Subject: SR 429 (Wekiva Parkway)/SR 417 and Interstate 4 Value Engineering Study  
Recommendation Dispositions.

FPID: 240200-4-52-01

## SR 429 (Wekiva Parkway)/SR 417 and I-4 Interchange

### Value Engineering Study **Draft** Report

**RECOMMENDATION No. 2: Adopt the I-4 Ultimate typical section**

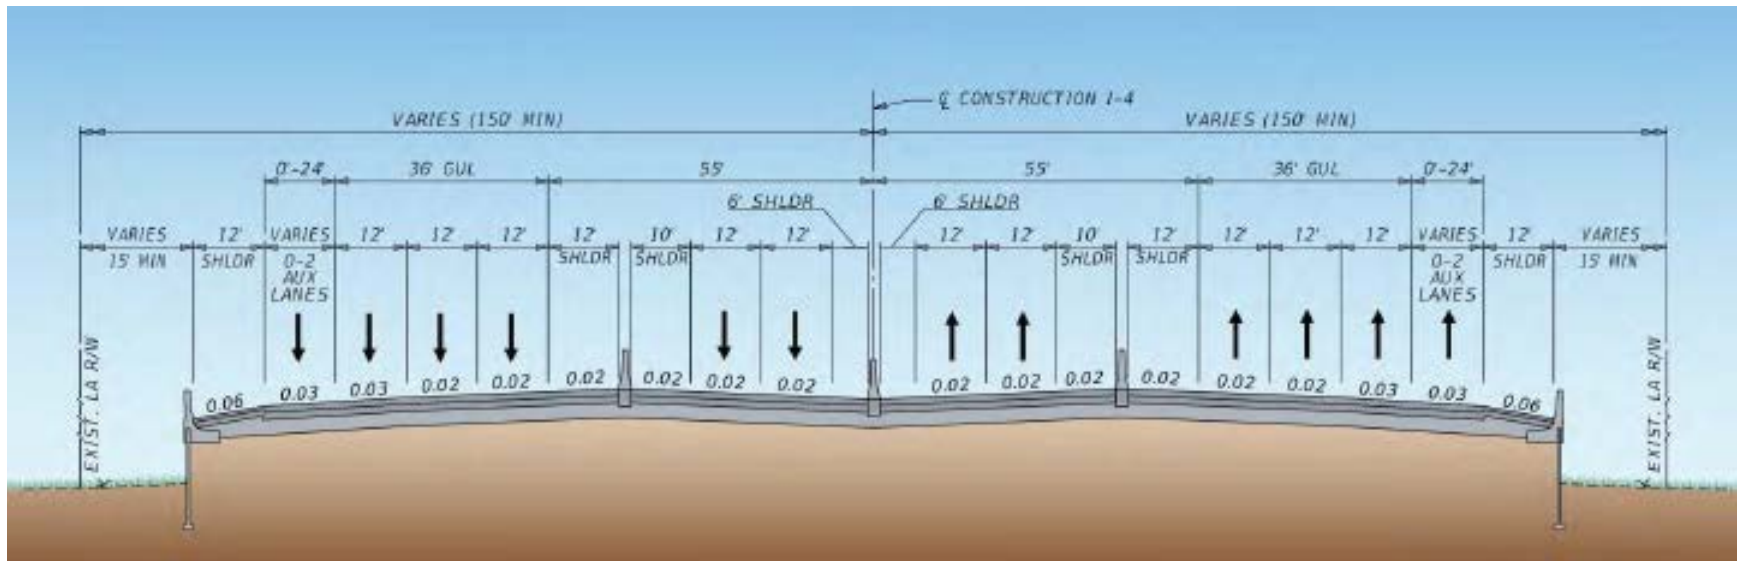
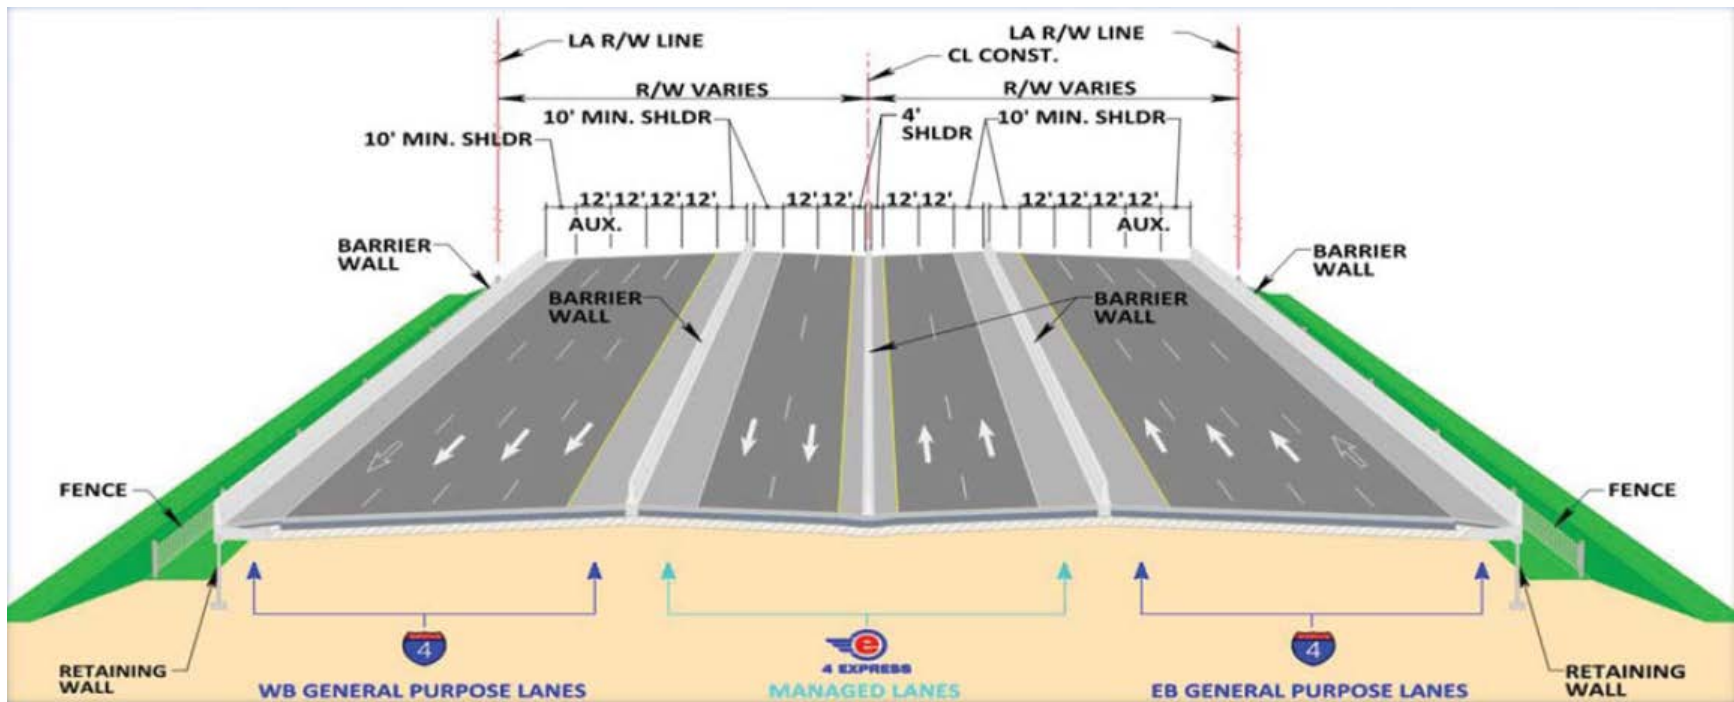
Recommendation 2: Adopt the I-4 Ultimate typical used through downtown Orlando and proposed for  
use on the remainder of Segment 3 to the north and south of this project. This will keep consistency  
through the corridor and reduce the roadway footprint.

Accepted. I-4 typical will match the I-4 ultimate.

**RECOMMENDATION No. 6 Modify the entrance to the westbound C-D to Station 2515+00:**

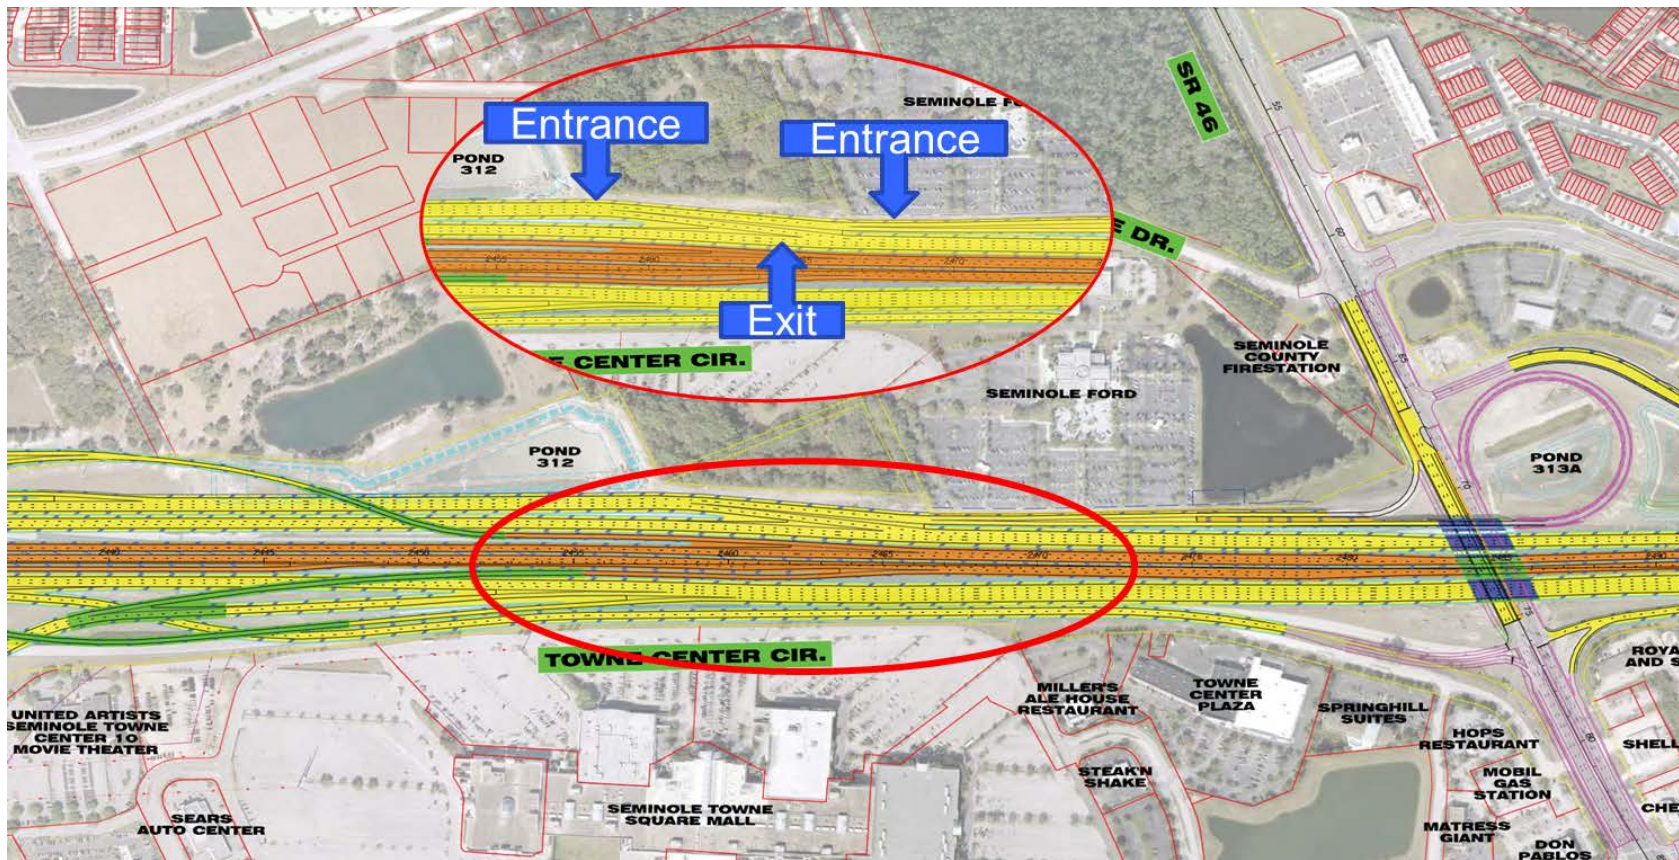
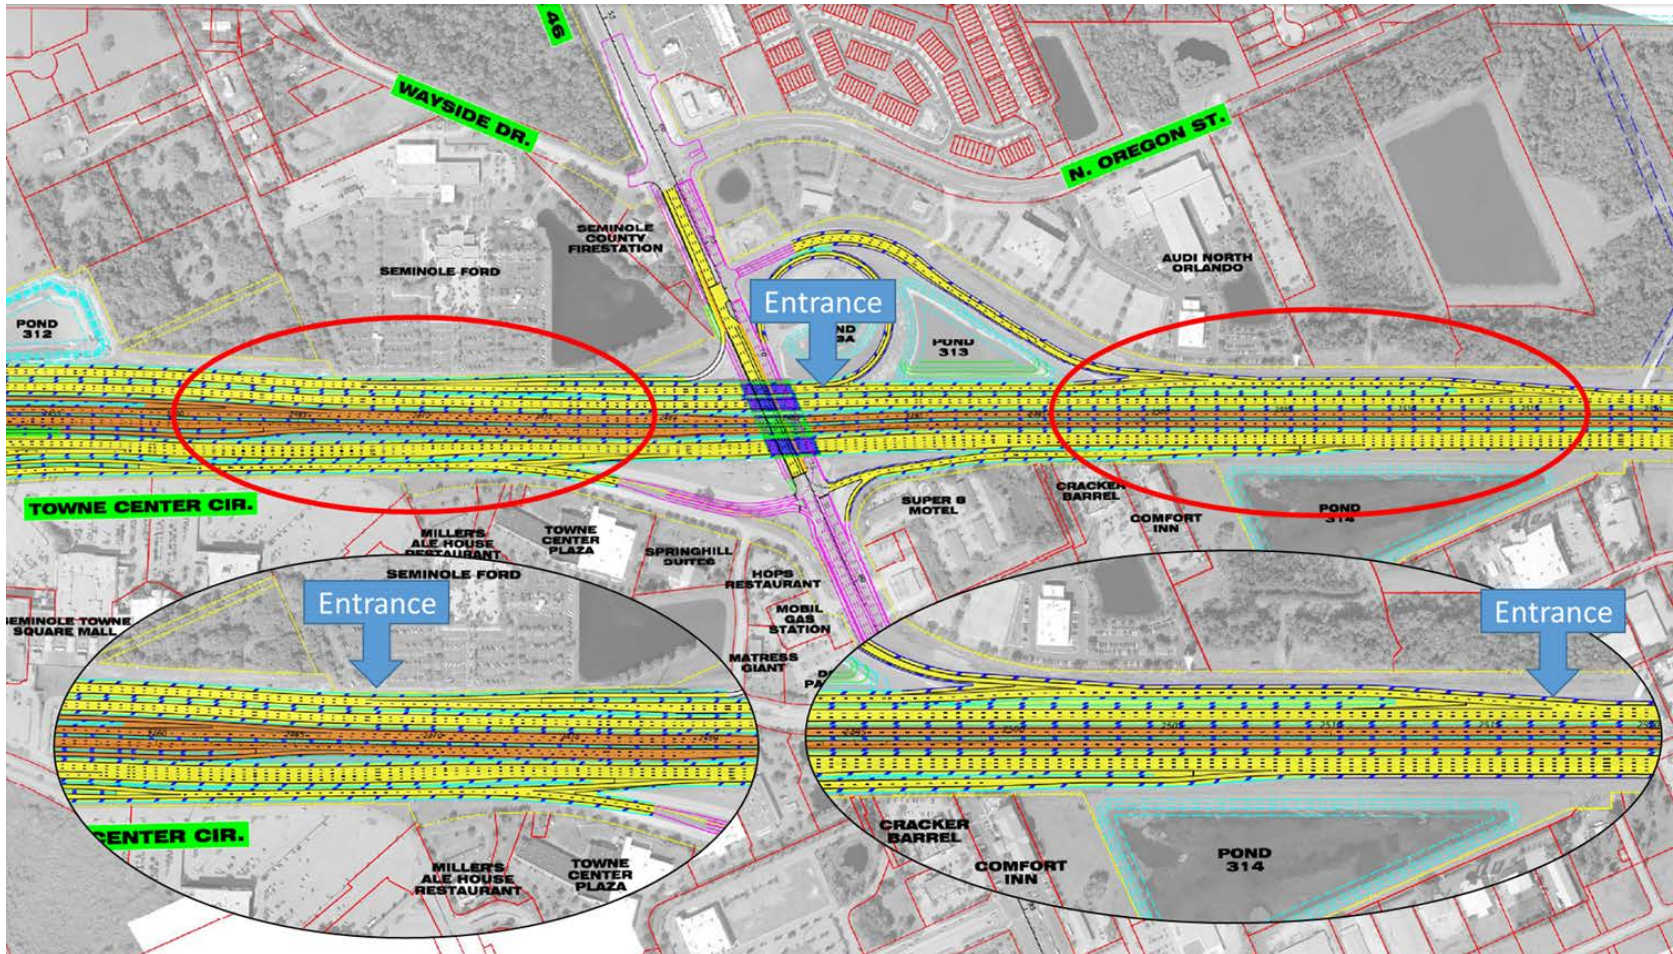
Recommendation 6: Shift the entrance to the C-D road north to begin approximately at station 2517+00.  
The C-D system continues over SR 46 where the bridge required was recently built for this condition.  
From SR 46 the C-D road continues under CR 46A and ties back into the westbound general use lanes.

Accepted. This recommendation was incorporated into the 4 alternatives developed. An operational  
analysis was performed for each of the alternatives and this did not create an issue.

**RECOMMENDATION No. 9: Eliminate the right of way take on International Parkway in front the apartment complex (via variation)**

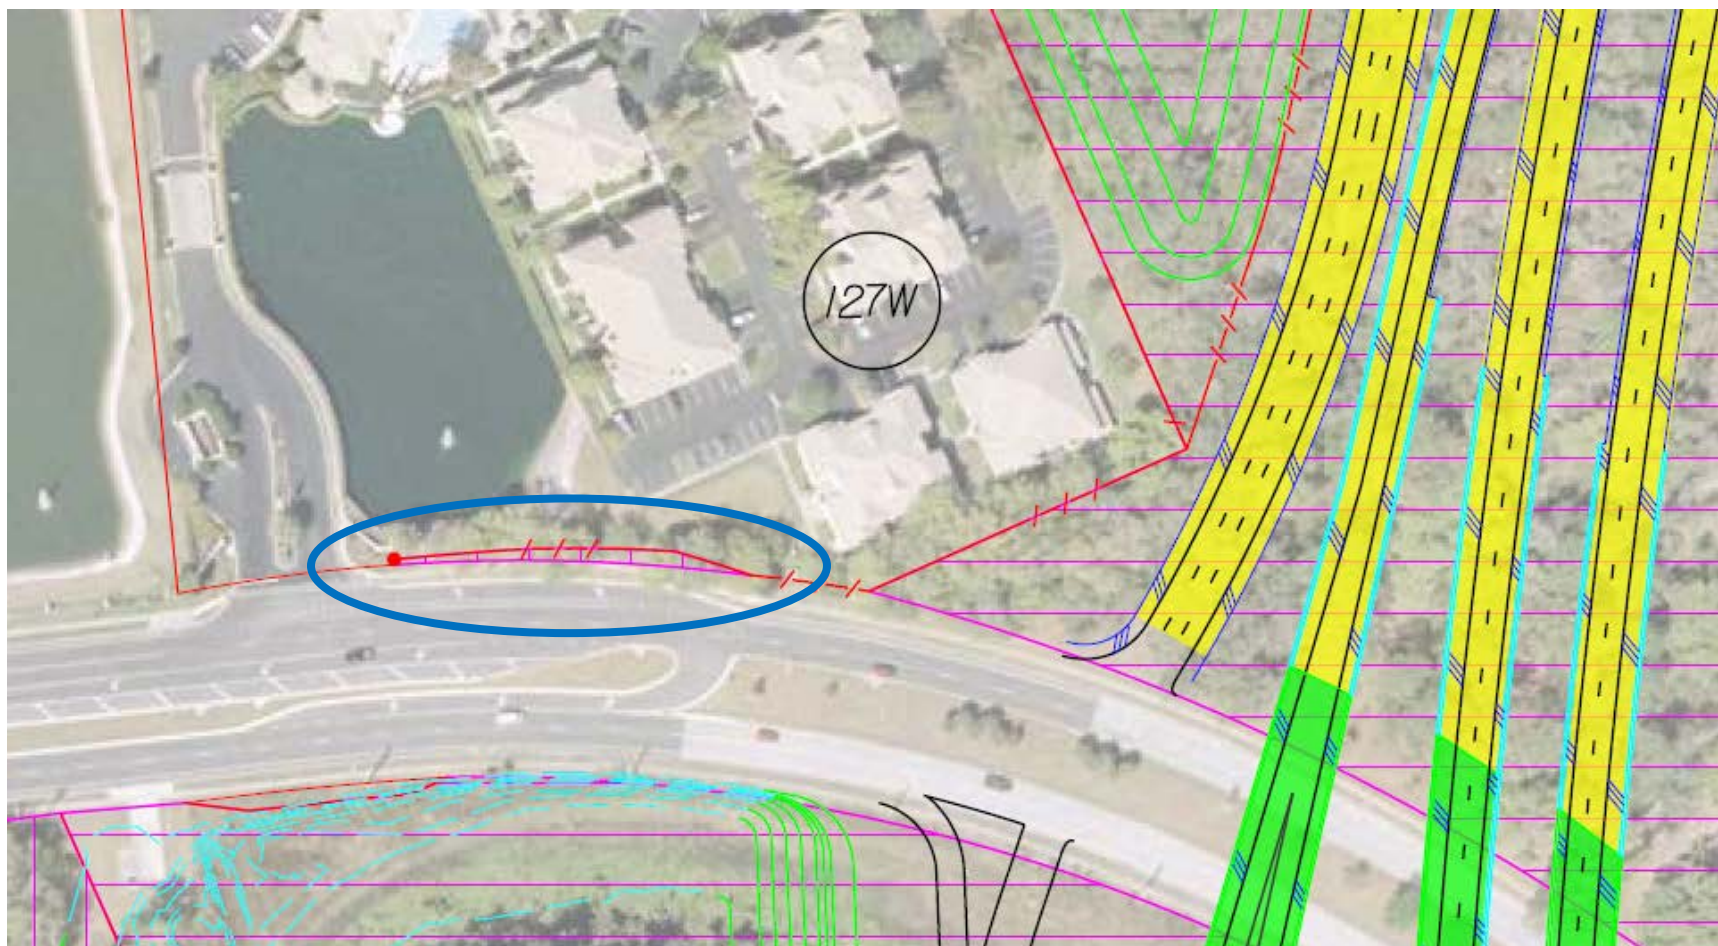
Recommendation 9: Eliminate the right of way take on International Parkway in front the apartment  
complex (via variation).

Accepted. It appears that the right of way impacts can be eliminated. During the line an grade  
phase this recommendation will be fully evaluated. (Atkins)

**RECOMMENDATION No. 16: Eliminate the direct connects from SR 429 to I-4 for Express Lanes**

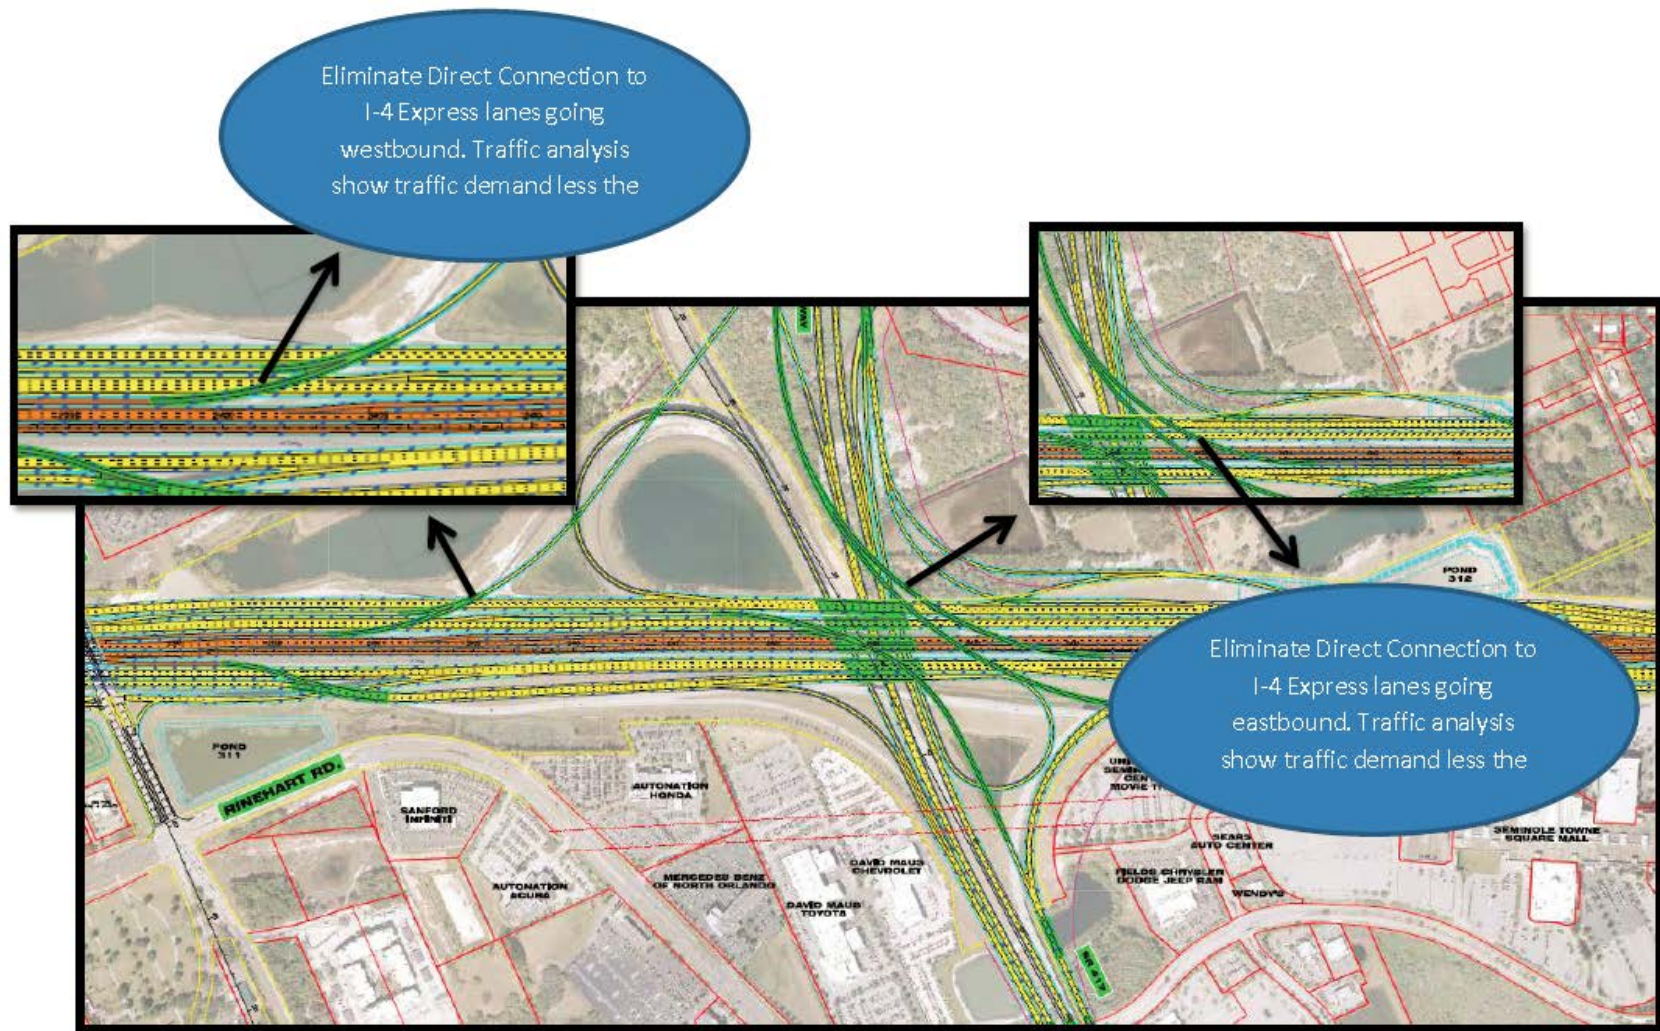
Recommendation 16: Eliminate direct connections to I-4 express lane, going from SR 429 eastbound to I-  
4 westbound and from SR 429 eastbound to I-4 eastbound. An additional slip ramp could be constructed  
further north on I-4 to provide access to the express lanes going eastbound. There is already an existing  
slip ramp to I-4 express lanes going westbound just south of Lake Mary Boulevard proposed.

It's important to point out that traffic volume for the design year is expected to be below 200 vph at peak  
hour on these connections.

An additional suggestion to this alternative would be to eliminate direct connections to I-4 coming from SR 417 onto I-4 express lanes eastbound and westbound. Traffic volumes for the design year are below 300 vph at peak hour. Traffic would still have access to the express lanes utilizing the slip ramp farther west and east (if the slip ramp is constructed).

Accepted. The DDI alternative developed removes the direct connections from toll to express. The operations were analyzed and this alternative operates similar to the other three alternatives.

**RECOMMENDATION No. 18: Salvage the existing connection from International Parkway to SR 417 to provide access to SR 417 southbound**

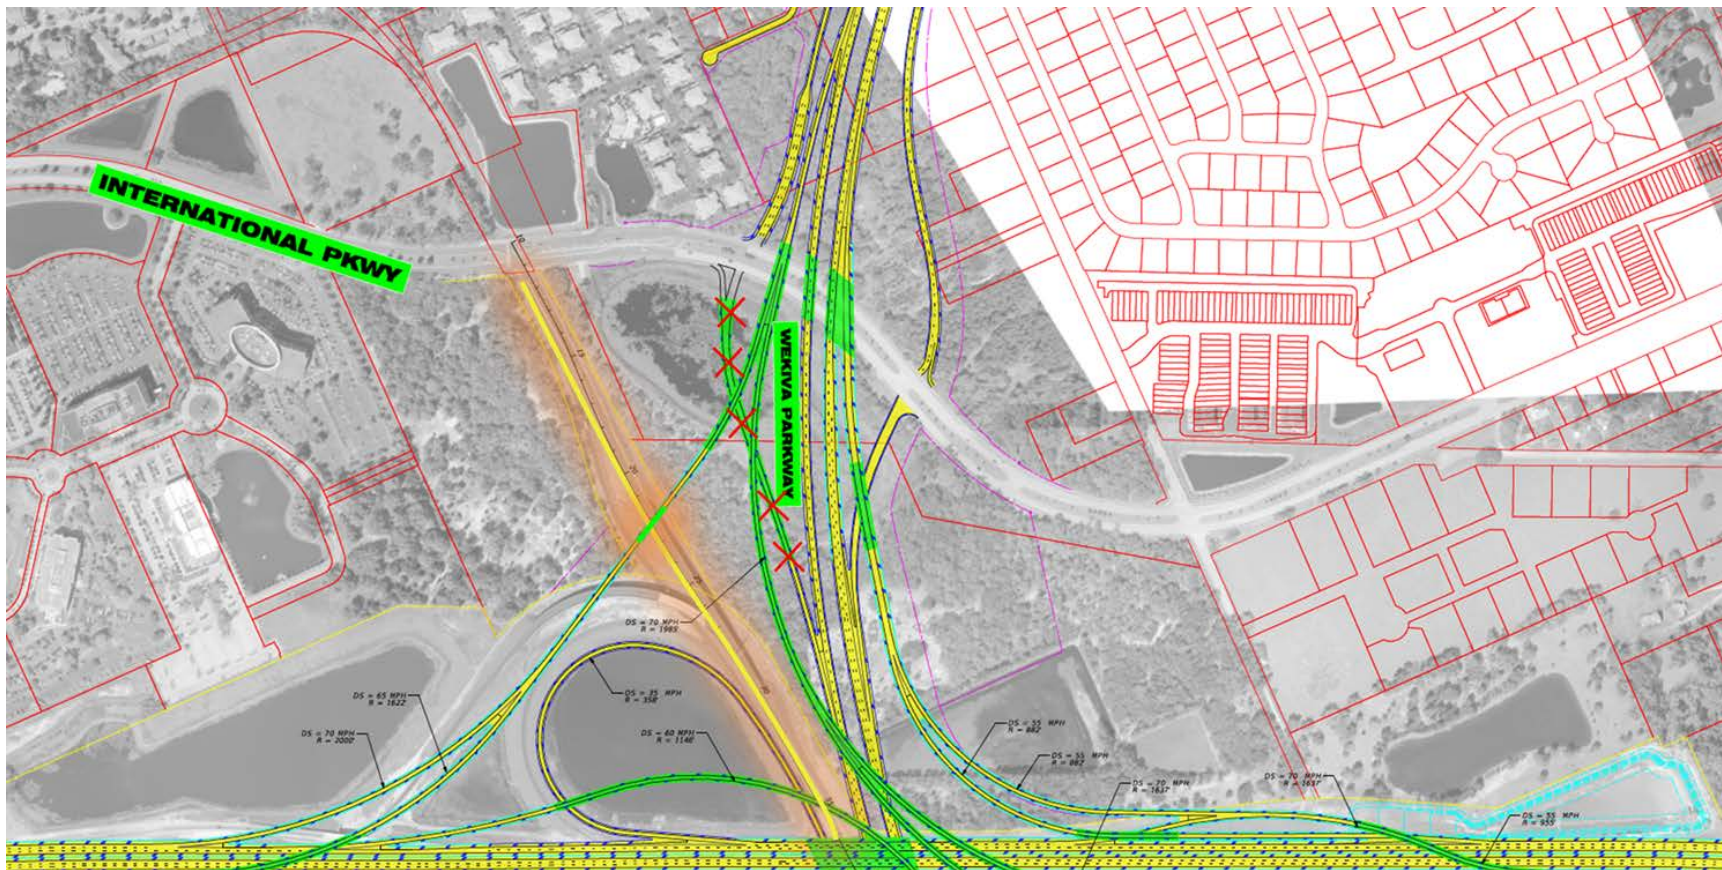
Recommendation 18: Salvage the existing connection from SR 417 northbound to International Parkway. Convert this connection from an off-ramp to an on-ramp for International Parkway to SR 417 southbound.

Accepted. Two concepts (Alt 3 & 4) utilize the existing connection to International Parkway.
